ED-HMI3630-156C

PCN

Product Change Notice 1

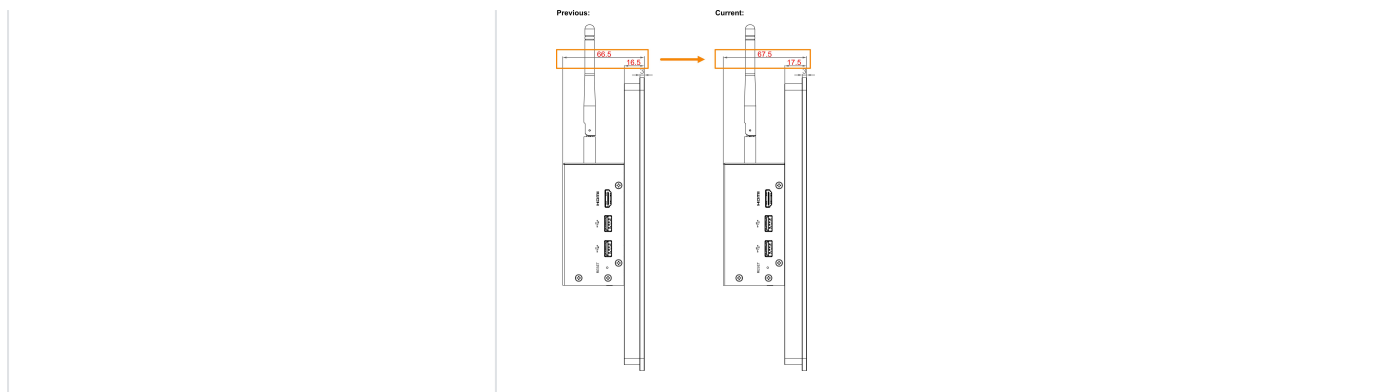
Changes	Results
LCD bezel thickness increased by 1mm	We have optimized the LCD bezel structure to provide additional clearance for internal cable routing. - LCD bezel thickness: adjusted from 16.5mm to 17.5mm. - Total product thickness: correspondingly adjusted from 66.5mm to 67.5mm.
